# UNITED STATES PATENT AND TRADEMARK OFFICE

APPLICATION NO.	FILING DATE	FIRST NAMED INVENTOR	ATTORNEY DOCKET NO.	CONFIRMATION NO.
09/336,207	06/18/1999	ROBERT G. MCCrackEN	8594560/9702	7367
26386	7590	02/09/2005	EXAMINER	
DAVIS, BROWN, KOEHN, SHORS & ROBERTS, P.C. THE FINANCIAL CENTER 666 WALNUT STREET SUITE 2500 DES MOINES, IA 50309-3993			HORTON, YVONNE MICHELE	
			ART UNIT	PAPER NUMBER
			3635	
DATE MAILED: 02/09/2005

**Office Action Summary**

***Claim Rejections - 35 USC § 103***

EXAMINER'S ATTACHMENT

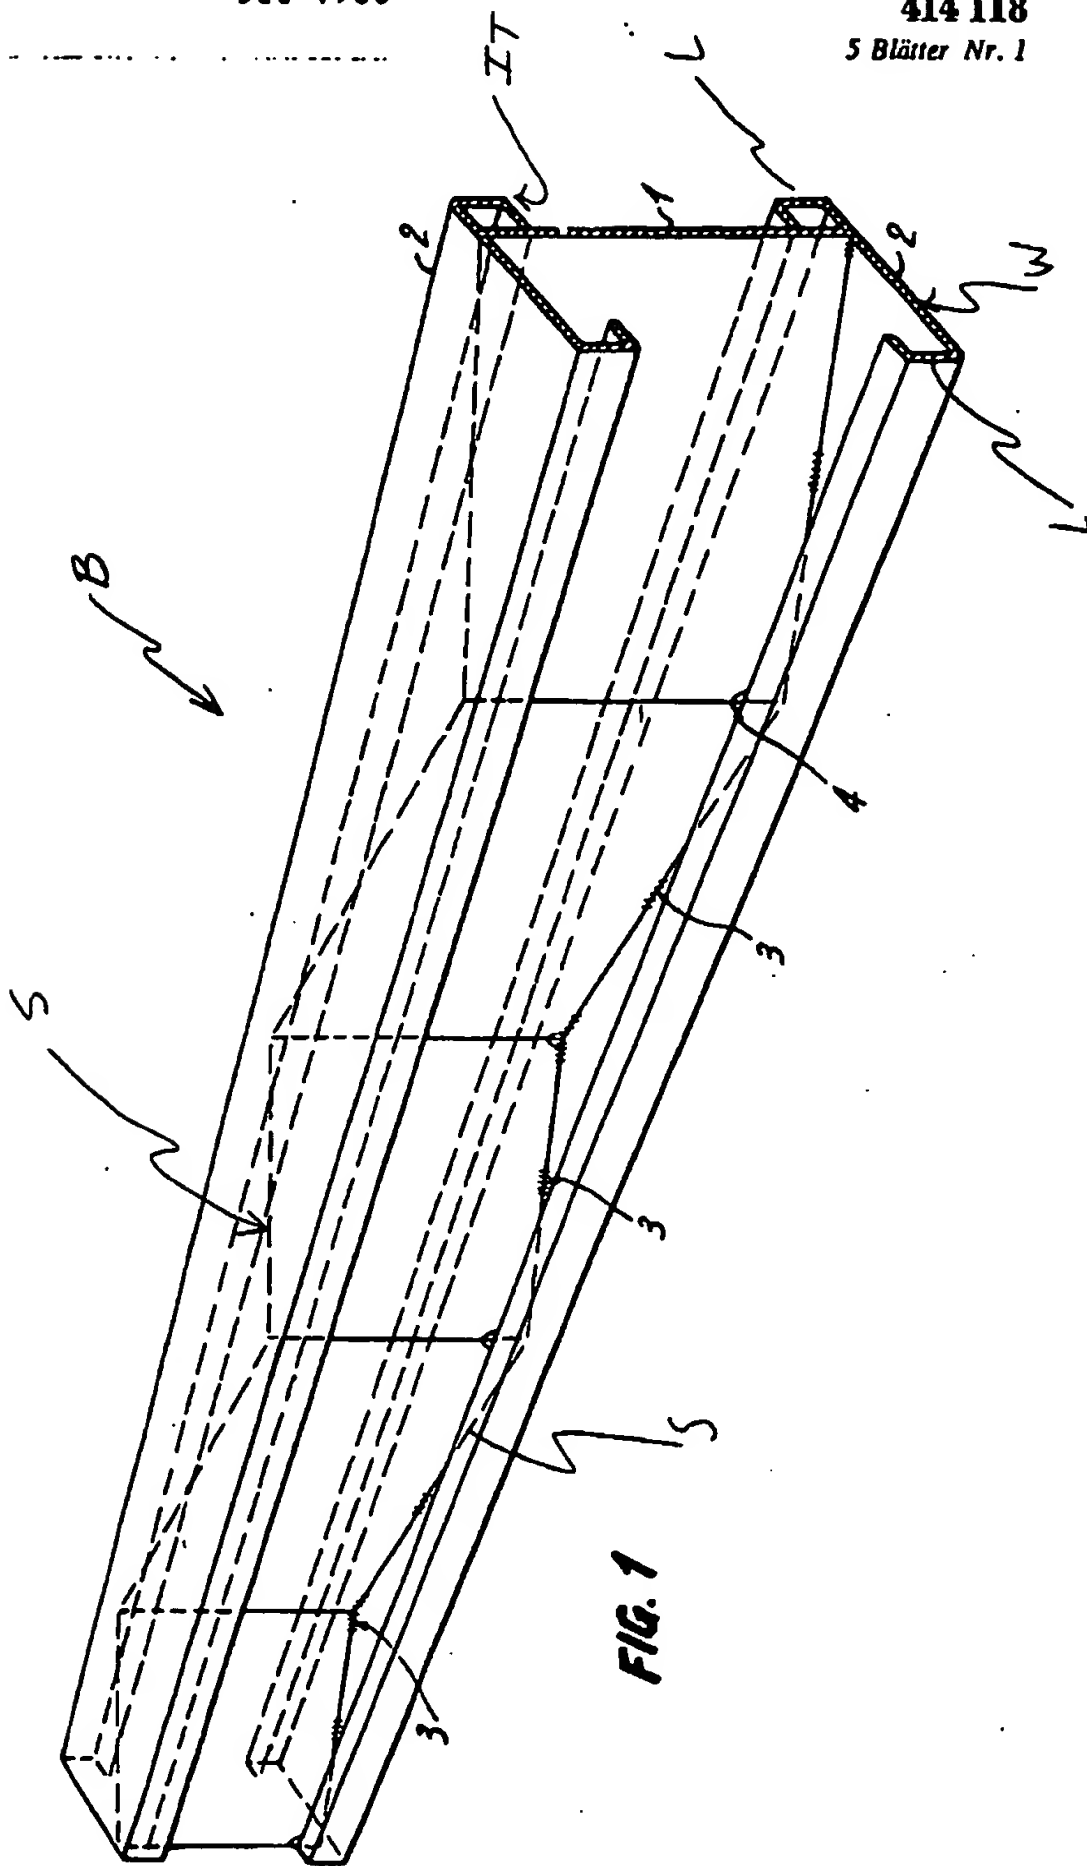
Claims 1,4-5,8-10 and 12 stand rejected and claims 13 and 14 are rejected under 35 U.S.C. 103(a) as being unpatentable over CH 0004141 18 in view of U.S. Patent #3,716,959 to BERNARDI. CH 000414118 discloses a beam (B) including a pair of longitudinally extending and opposing "C-shaped" flanges (2) each having a central web section (W), a pair of inwardly extending leg sections (L) and an in-turned portion (IT) (See the marked-up attachment); and a convoluted web member (1) having alternating protrusions (4) adjacent to leg sections (L), (See the marked-up attachment). The web member (1) is secured to the central web section (W) of the flanges (2), and the protrusions (4) are secured to the leg sections (L) by securing means (3) and the in-turned portions (IT) are also indirectly secured by means (3) also. CH 000414118 discloses the basic claimed beam except for the use of end plates. The use of brackets and end plates to provide for the capability of interconnecting beam members is old and very well known in the art. BERNARDI teaches that it is known in the art to provide a beam structure (10) with end plates (36) wherein the endplates (36) along with welds (39,41,43) provide a rigid, column 2, lines 50-52, "full moment " connection, column 1, lines 45-51. It would have been obvious to one having ordinary skill in the art to provide the beam member of CH 000414118 with the end plates of BERNARDI in order to enable adjacent beam structures to be secured together and to provide the beam

Regarding to claims 8 and 9, the web member (W) is secured to the central web section (20) of the flanges (2) by welds (3), and the protrusions (4) are also secured to the leg sections (L) and in-turned portions (1T) by welds (3).

In further regards to claim 11, the flanges (2) are C-shaped and leg sections (2) include in-turned portions (IT), (See also the marked-up attachment).
